APPENDIX D: UFAS INTERPRETATIONS AND WAIVERS

D.3 DMFO QUESTIONS AND ANSWERS. The Defense Medical Facilities Office prepared a series of questions relative to UFAS and forwarded them to the ATBCB for interpretations. The numbers listed in the Reference column relate to paragraphs and pages in Fed-Std-795, "Uniform Federal Accessibility Standards." Answers to the questions are indicated in **bold** type.

SUBJECT: Waivers and Modifications of Accessibility Standards
for Psychiatric Ward at Portsmouth Naval Hospital

FIGURE D-1

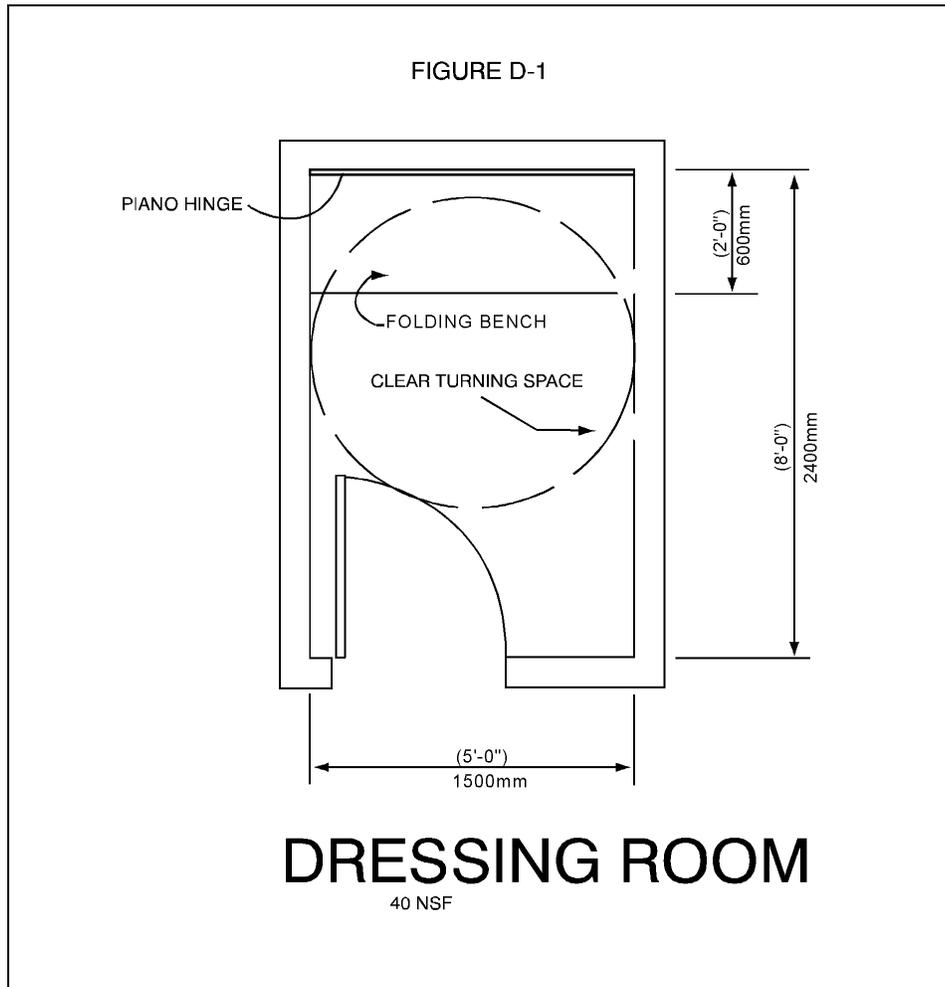
D.2.1 DRESSING ROOMS. In new construction, where dressing rooms are provided for use by the general public, patients, customers, or employees all shall be located on an accessible route. In existing construction, where structural impracticability can be demonstrated, one dressing room for each sex on each accessible floor/level shall be made accessible.

D.2.1.1 Clear Floor Space. A clear floor space allowing a person using a wheelchair to make a 180-degree turn shall be provided in every dressing room entered through a swinging or sliding door. No door shall swing into any part of the turning space. Turning space shall not be required in a private dressing room entered through a curtained opening at least 32" wide if clear floor space complying with section "Space Allowance and Reach Ranges" renders the dressing room usable by a person using a wheelchair.

D.2.1.3 Bench. Every dressing room shall have a 24"(min) by 48"(min) bench fixed to the wall along the longer dimension of the bench and not necessarily the room. The bench shall be mounted 17" to 19" above the floor and may be hinged. Clear floor spaces shall be provided alongside the bench to allow a person using a wheelchair to make a parallel transfer onto the bench. The structural strength of the bench and attachments shall comply with section "Structural Strength". Where installed in conjunction with showers, swimming pools, or other wet locations, water shall not accumulate upon the surface of the bench and the bench shall have a slip-resistant surface.

D.2.1.4 Mirror. A full-length mirror, measuring at least 18" wide by 54" high, shall be mounted in a position affording a view to a person on the bench as well as to a person in a standing position.

FIGURE D-3

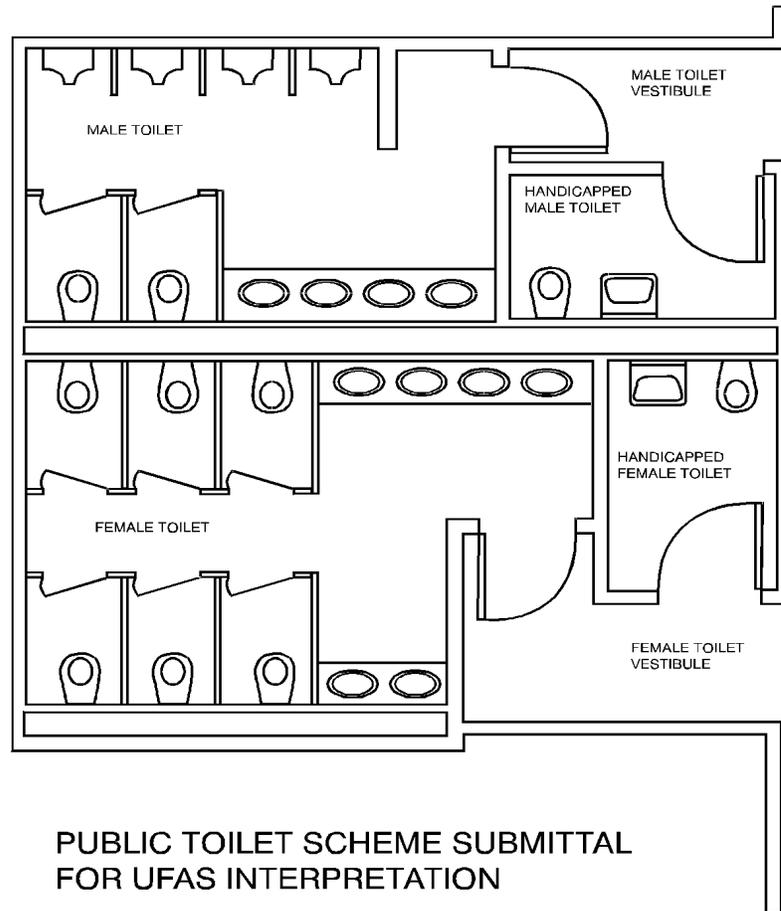
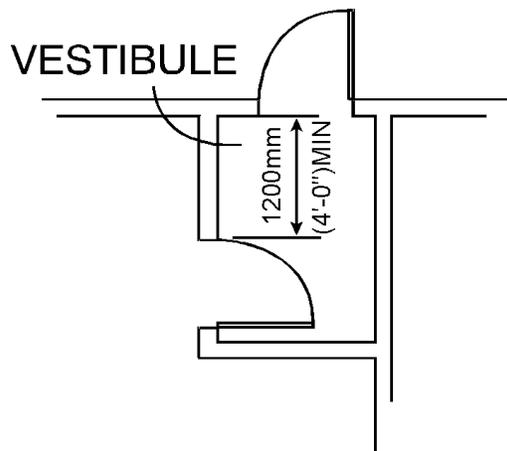
- D.3.3 4.1.4(9)(b),
p10
- This states that all common use toilet facilities shall be accessible. If an accessible toilet room is placed at the entry to a public toilet, does this satisfy this requirement even though the remainder of the toilet is not accessible? See example plan in Figure D-3.

- The example plan does not meet the requirements for new construction, however, in some alterations the proposed arrangement may be regarded as fulfilling the requirements.**

TWO HINGED DOORS IN SERIES SUBMITTAL
FOR UFAS INTERPRETATION

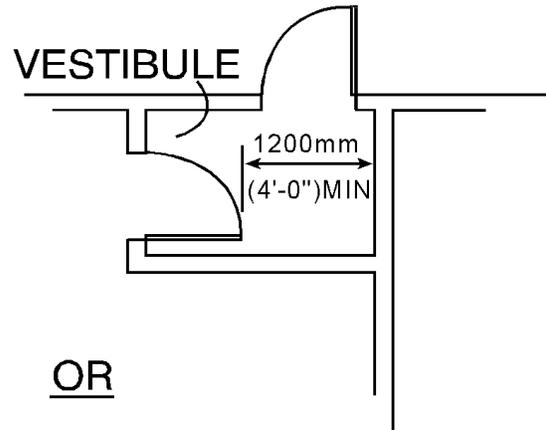
If two doors in series are located in walls perpendicular to each other, is a minimum clear distance of 48 inches required? See example plans in Figure D-5.

Yes.

BATHROOM SCHEME SUBMITTAL FOR UFAS INTERPRETATION

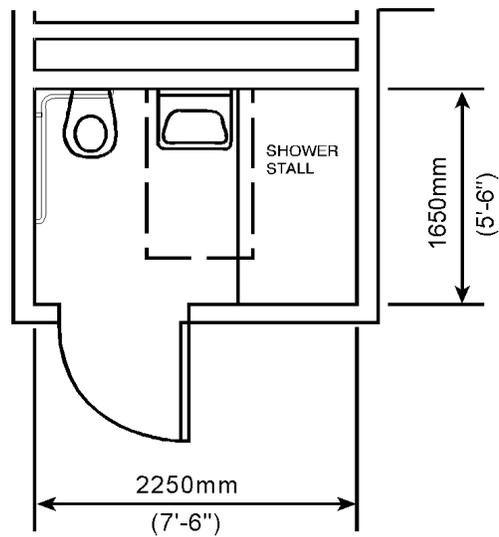
If there is a shower with no curb nor any other obstructions such as shower doors, is it allowable to have a turning space or clear space of another fixture in a single use toilet overlap the shower area? See example in Figure D-6.

NOTE: CLEAR FLOOR SPACE OF SINK OVERLAPS SHOWER
STALL, WHICH HAS NO CURB

Figure D-6 does not include the required 36" x 60" clear floor space at the shower. If it did, there would also be sufficient clear floor space for the lav without encroaching on the shower.

Fig. 31 (b)
Lavatory Clearances

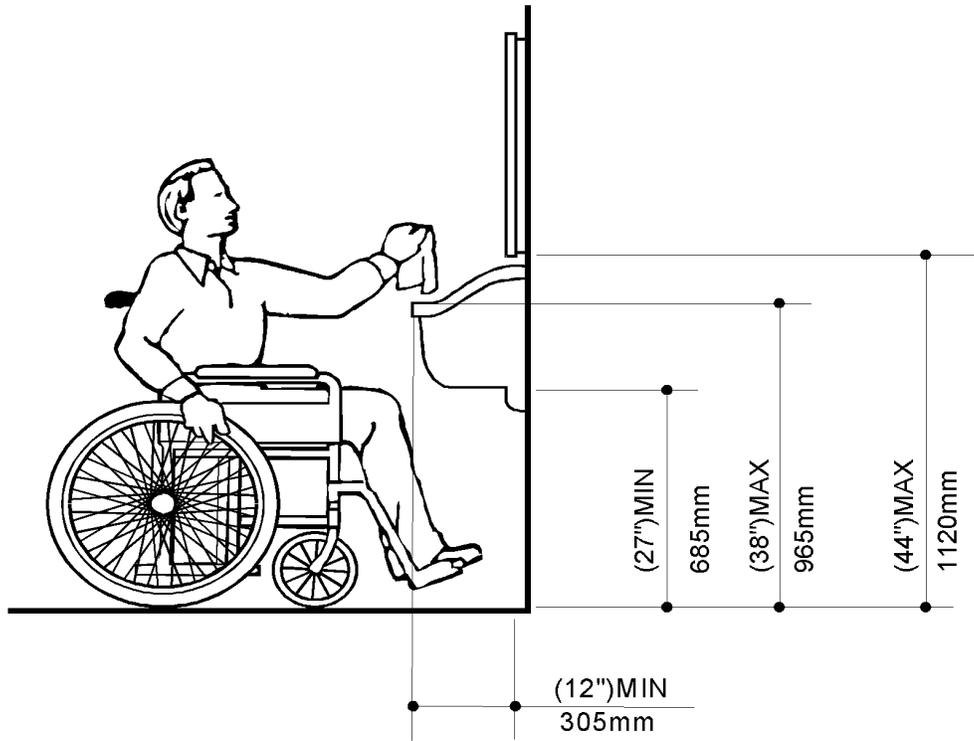
Similarly, because lavatories can be removed from the wall and used as weapons, vandal-proof lavatories are desirable in psychiatric wards. The typical vandal-proof lavatory is 14 inches wide, 12 inches deep, and 10 inches high. The typical accessible lavatory is 20 inches wide, 18 inches high, and 6 inches high. Accordingly, the following modification of § 4.19.2(M) is authorized for the psychiatric ward at Portsmouth Naval Hospital:

4.19.2(M) Height and Clearances. Vandal-proof (prison-style) lavatories shall be mounted so that 50 percent comply with Figure 31(b) and 50 percent with Figure 31(c).

The lavatories in Figure 31(b) shall be mounted with rim or counter surface no higher than 38 inches (965 mm) above the finished floor. Provide a minimum knee clearance of 27 inches (685 mm) below the lavatory. The lavatory shall project a minimum of 12 inches (305 mm) from the wall.

§ 4.19.6 Mirrors. When lavatories are mounted as shown in Figure 31(b), mirrors shall be mounted with the bottom edge of the reflecting surface no higher than 40 inches (1015 mm) from the floor.
